MEMORANDUM
Department of Ecology

SUBJECT: Boise Cascade - Steilacoom
Evaluation of Bottom Study Data Re: Memo
Sept. 28, 1971

SUBJECT: Boise Cascade - Steilacoom
Receiving Water and Bottom Study

SUBJECT: Boise Cascade outfall near Chambers Creek

Boise CASCADE OUT FALL

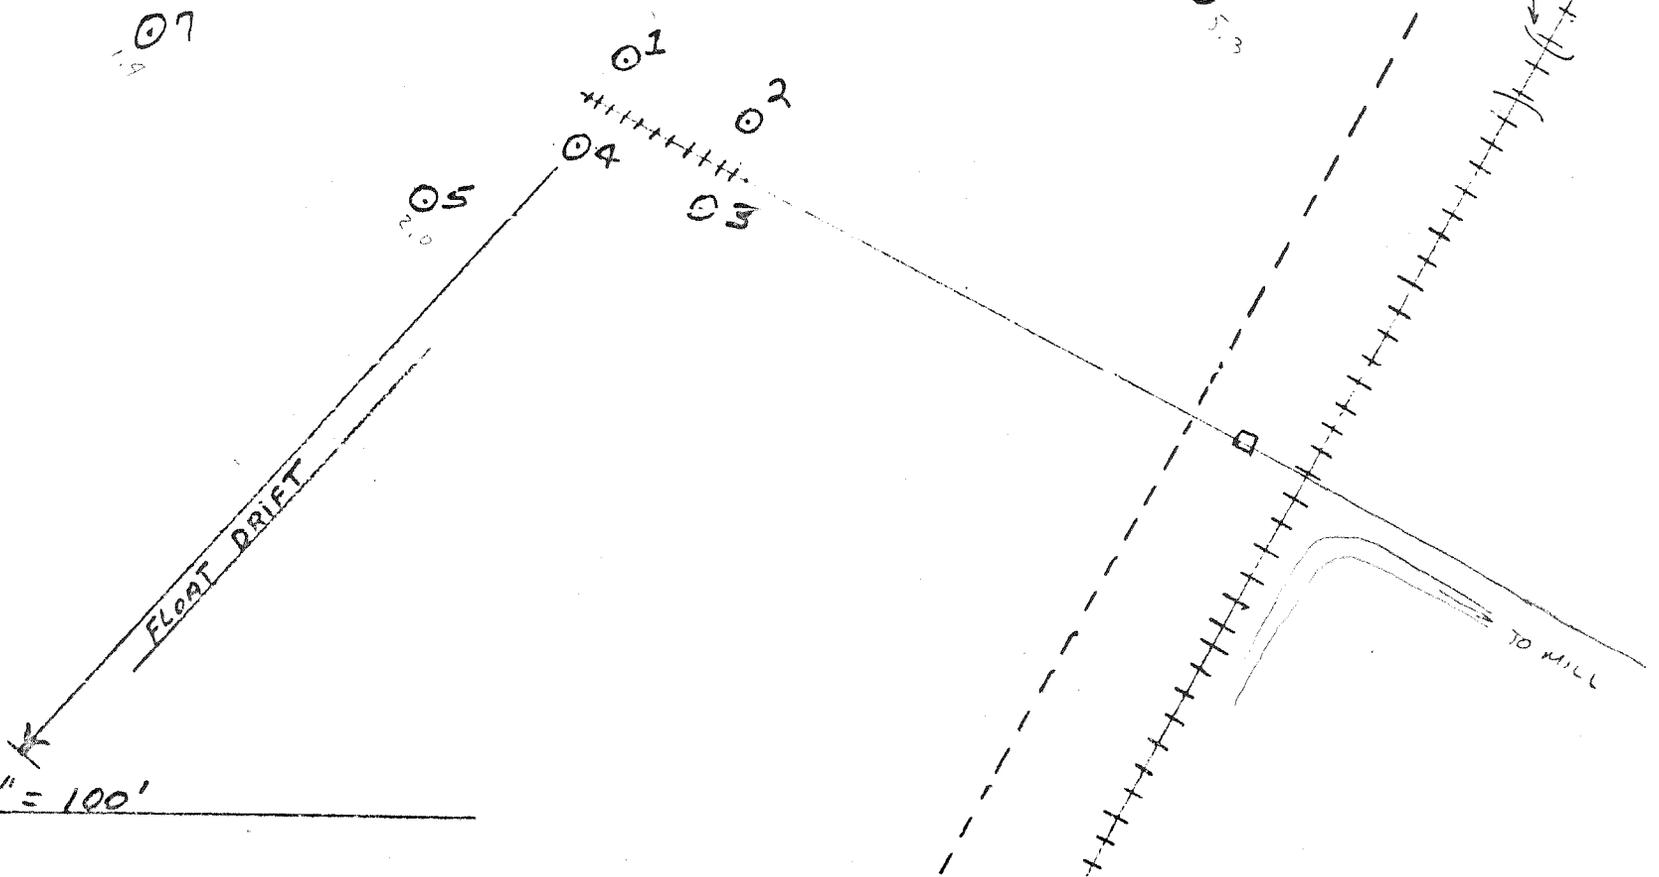
Zinc values on the surface at stations 1, 2, 3, and 4 are slightly higher than at stations 5, 6, and 7. Additional sampling would have to be done to determine if these higher values are significant. You could, I suppose, attribute the higher surface values to the influence of the Boise Cascade discharge.

The dry weight zinc values were obtained from the bottom grab samples. The sample at station 6 is nearly twice as high in zinc content as those samples collected from the other five stations. I think this can be attributed to the many years of discharging into the Chambers Creek estuary eventually creating a sludge deposit at the mouth of the estuary. This is further substantiated by the volatile solids analysis of the bottom samples. At station 6 the volatile solids are 5.3% of the total solids which is twice that found at the other station. EPA has established that any dredge spoil material which exceeds 6% must be disposed of on land.

I have no explanation for the lower Secchi disc readings at stations 2 and 3 except for the influence of the outfall.
